## **NUCLEAR REGULATORY COMMISSION**

Title:       Advisor Committee on Reactor Safeguards  
              Subcommittee on ESBWR

Date:                    Friday, September 24, 2010

## ESBWR Design Certification Chapter 7 I&C

Figure 7.3-8 SSLC/ESF Inter-Divisional Communication Detail

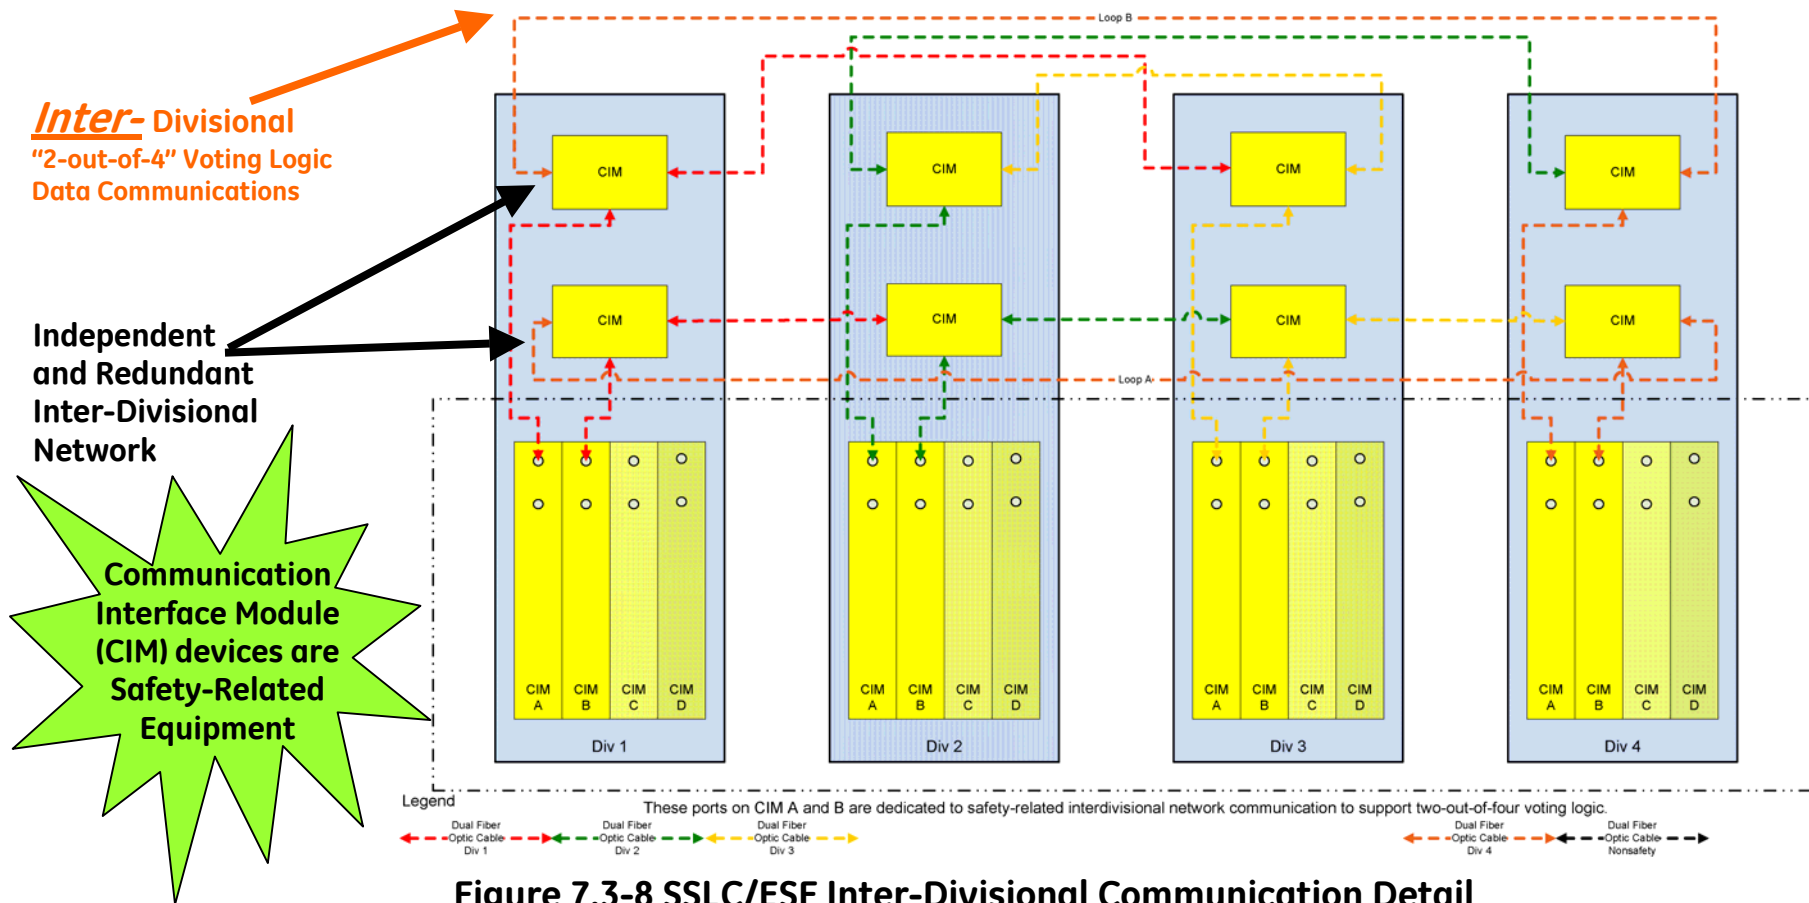
5 MR. POPPEL: First of all, if Romeo flips  
6 between this slide and the next one just back and  
7 forth, you can see the two networks, and you can see  
8 the two different communication cards. Okay? That's  
9 just meant to show that there are two cards, two  
10 networks, two sets of switches. They're completely  
11 redundant to one another, and they're completely  
12 independent of one another, so that, in other words,  
13 we can take N minus 2 failures in the system and still  
14 get the information we need to get a two out of four  
15 decision for ECCS initiation, and isolation decisions.

1 2, periodically, to Division 3, to Division 4, and  
2 same thing is happening with Division 2, Division 3,  
3 and Division 4. So, the data path is the  
4 communication card takes the information, puts it onto  
5 the network which is the switch, and the switch's  
6 rules are let's send the data around through the other  
7 switches, and you can see it's a loop, and it comes  
8 back to the original switch. So, if it comes back,  
9 that means the network is in tact. So, the response  
10 of the switch is to say all is well, and take the  
11 message off the network. That always happens.

12 If, in fact, the message doesn't come  
13 back, all is not well. Something has happened to  
14 interfere with the message. So, the switch's response  
15 to that is to send the data around in the other  
16 direction. Okay? So, for example, if you break the  
17 top network between red and green, so red tries to  
18 send -- Div. 1 tries to send to Div. 2, and the link  
19 is broken, so it sends the message around the other  
20 way to Div. 2. So, this is to demonstrate that if you  
21 actually have a fiber break, the data still gets to  
22 all three divisions, all three other divisions. And  
23 this is one of the redundant networks, so the other  
24 division is in tact, and still working, but the intent  
25 is to show that it's self-healing. Okay? If it goes

13 Well, first of all, the same rules hold,  
14 it goes around in the other direction. Okay? So, for  
15 individual divisional failures, we are completely N  
16 minus one. Okay? But we have told you we're an N  
17 minus two plant. So, for example, if I take out on  
18 this drawing Division 4, and Division 2, then you  
19 could properly tell me that the data never gets to  
20 Division 3. And, therefore, I will not be able to  
21 make a two out of four decision.

Figure 7.2-11a

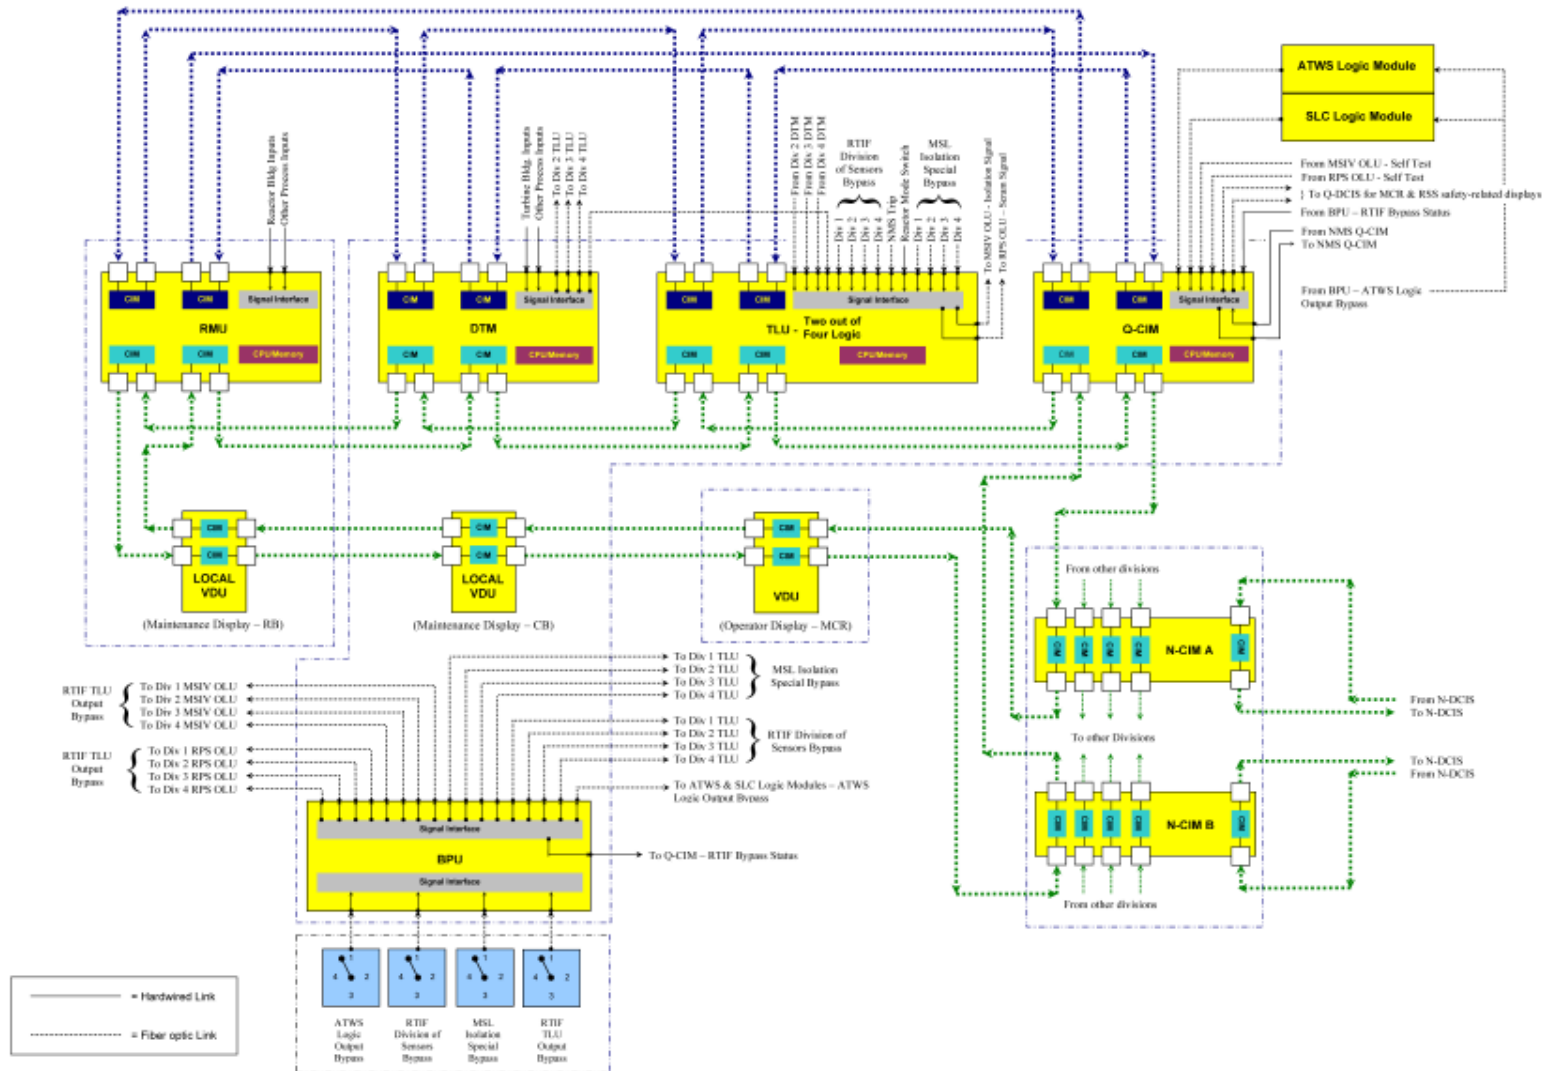
DCD Tier 2 Figure 7.1-1 shows the elements of the Q-DCIS and the N-DCIS with a very high-level functional representation. During the ACRS meeting, GEH presented additional architectural information, including a simplified diagram with a "safety ring." This level of architectural detail needs to be included in the DCD for the safety systems. Add figures with this level of detail to the DCD with corresponding discussion in the text as applicable.

# Add'l Design Detail – New Fig. (1/8)... Figure 7.2-11a

## From: RAI 7.1-139 – Question 3

**Figure 7.2-11b**

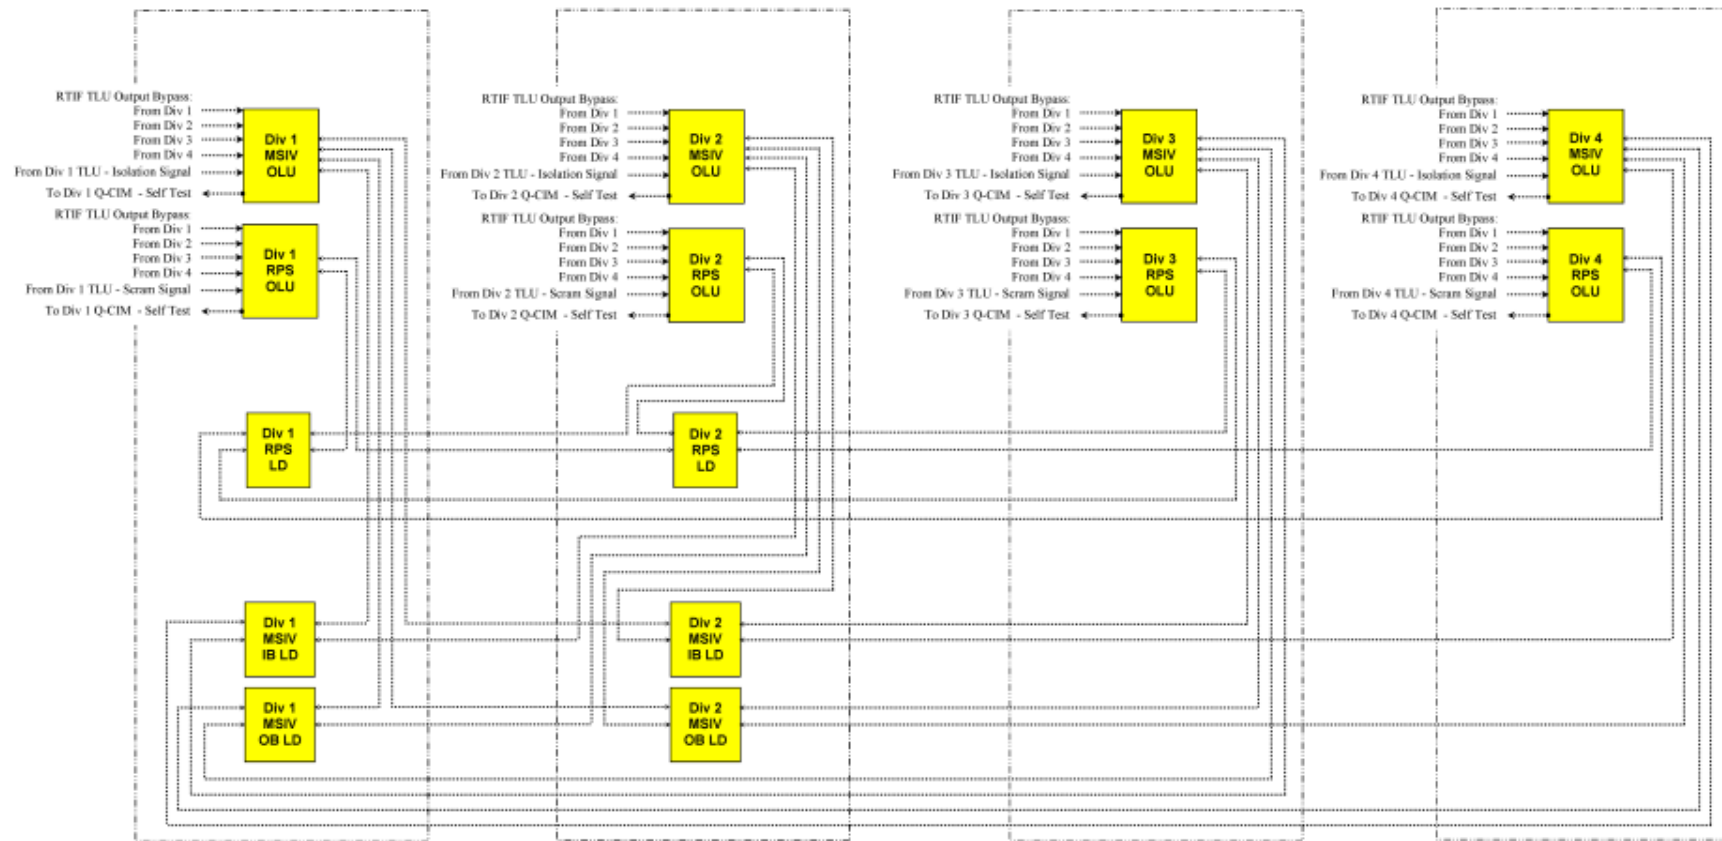
5 MEMBER BROWN: I'm looking at your figure  
6 here, which I saw in the Rev. 7 stuff, also. And I  
7 see the TLU. Then when I go look at Figure 7.2-1 in  
8 the DCD, it shows the output of the TLU going to an  
9 RPS output logic unit, which is not shown on here that  
10 I can see.

15 MEMBER BROWN: Well, I don't know. I  
16 haven't gone through your entire presentation. But, I  
17 mean, it's Figure 7.2-1, shows that, and it goes --  
18 so, is the output logic unit -- why does it have to be  
19 a microprocessor? All it's doing is getting a  
20 division output unit singing a one or a zero off to --  
21 or something, whatever you're sending. It's kind of  
22 maybe a load -- but it goes off to a load driver down  
23 where you have all the scram solenoids.

**Add'l Design Detail – New Fig. (2/8)... Figure 7.2-11b**  
**From: RAI 7.1-139 – Question 3**
